POINT BEACH NUCLEAR PLANT UNIT NO. 2

AMENDMENT TO FACILITY OPERATING LICENSE

Amendment No. 7
License No. DPR-27

CHANGE NO. 13 TO THE TECHNICAL SPECIFICATIONS

FIGURE 15.3.10-1

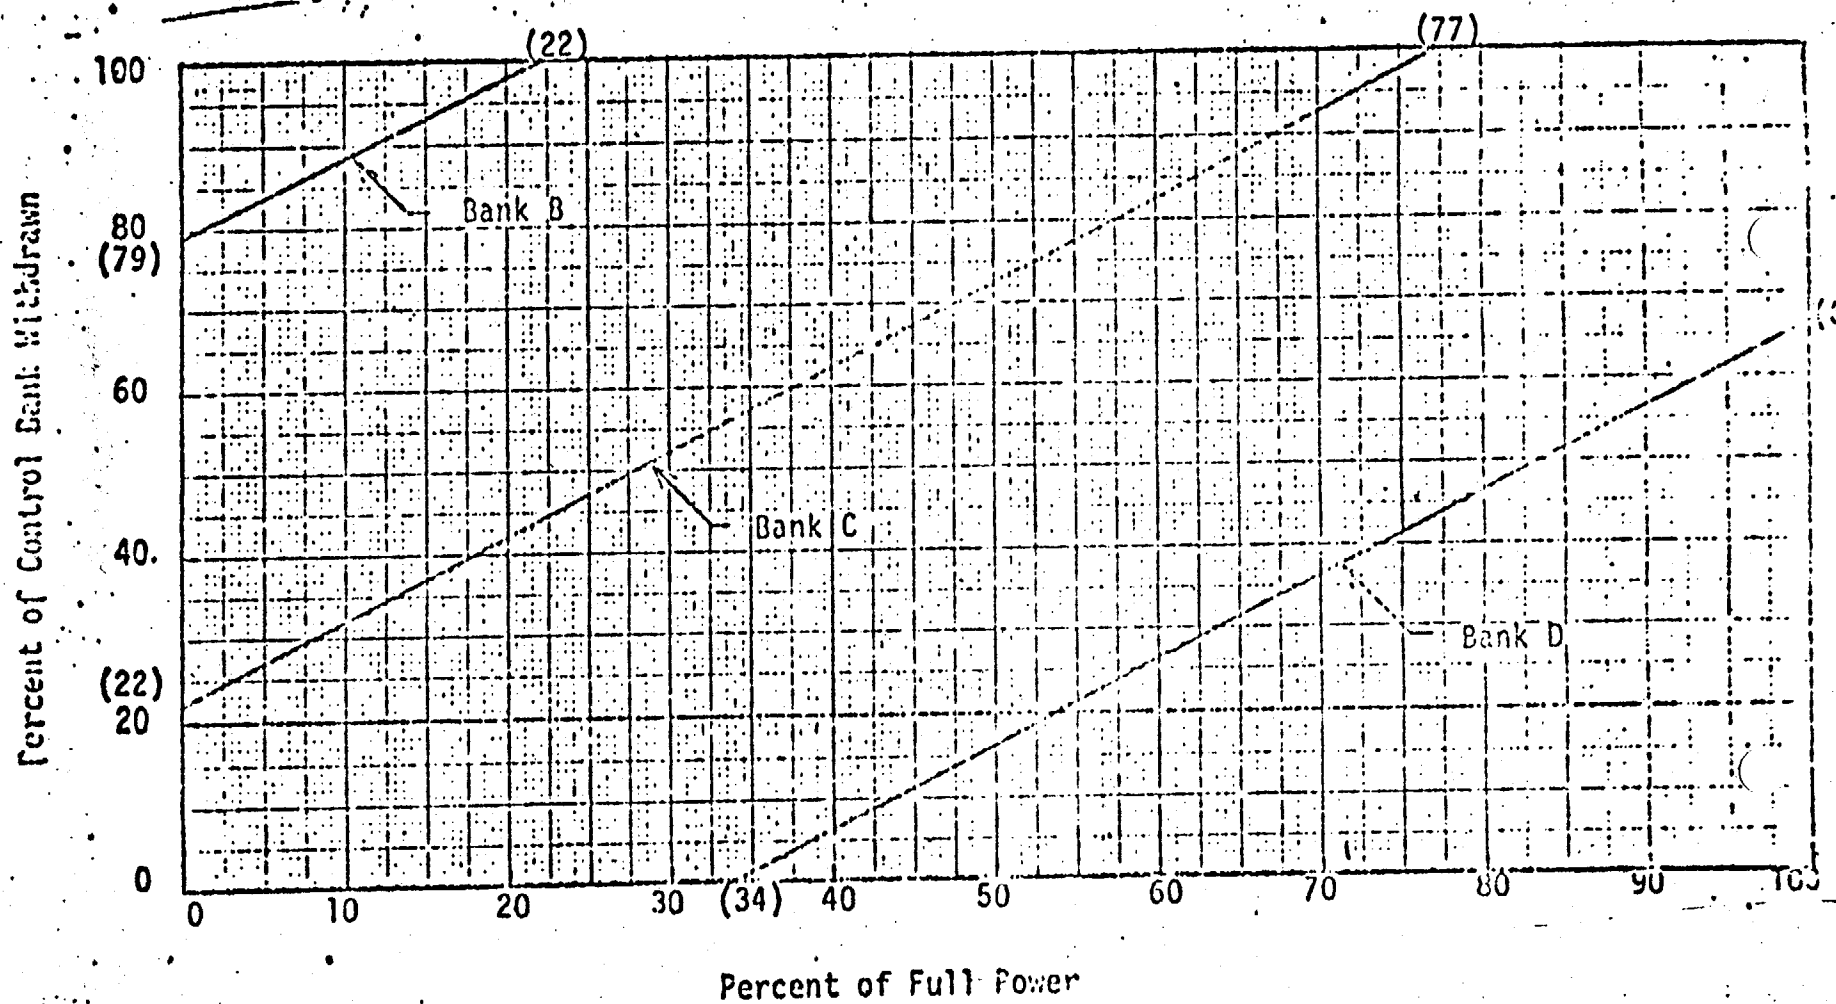
Replace Figure 15.3.10-1 with the attached figure.

Full Length Rod Insertion Limits
Point Beach Unit 2 - Cycle 2
